To: T10 Technical Committee
 From: Luben Tuikov, Vitesse Semiconductor (ltuikov@vitesse.com)
 Date: 20 October 2006
 Subject: 06-460r2 SAM-4 Time bounds of task states

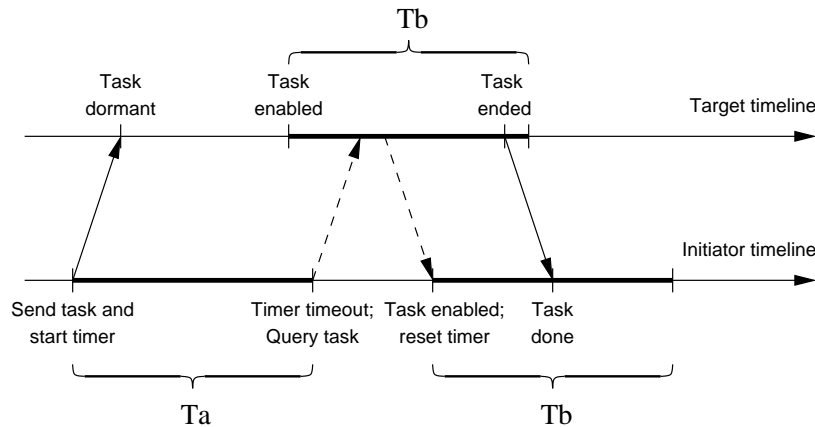
The suggested changes are that the timeout value specify time spent in the TASK ENABLED and TASK ENDED task state. This of course implies that TASK ENABLED and TASK ENDED state is bounded in time. This is not a problem since the time bounds are not specified in the Architecture. As far as the Architecture is concerned a time bound of 100 million years is just as good as 100 microseconds, for example.

| Suggested changes are that this proposal, in a form as agreed to by the T10 committee, be included in SAM-4.
